December 7, 2017

ROUND LAKE DAM
CONTRACT NO. 1 – HANDRAIL FABRICATION
CONTRACT #4547-928-7R1-0-C1

Questions and Answers

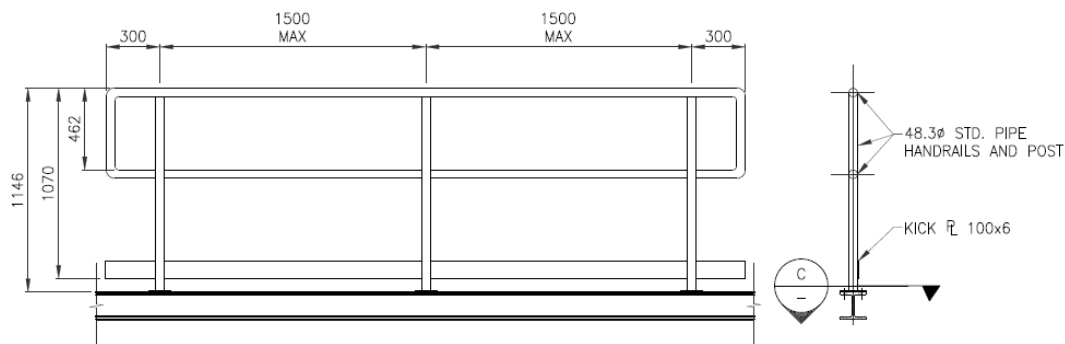
Q2 - Dwg # 8/8 is calling up paint systems refer to Spec 05501 misc metalwork, but I can't find Spec 05501 in the bid documents.

A2 – DWG 209173 Sheet 8/8 the following phrase should be eliminated “05501 MISCELLANEOUS METALWORK” and replaced with “05 50 01 MISCELLANEOUS METALWORK”

DWG 209173 Sheet 8/8 the following phrase should be eliminated “09901 PAINTING METALWORK” and replaced with “09 90 01 PAINTING METALWORK”
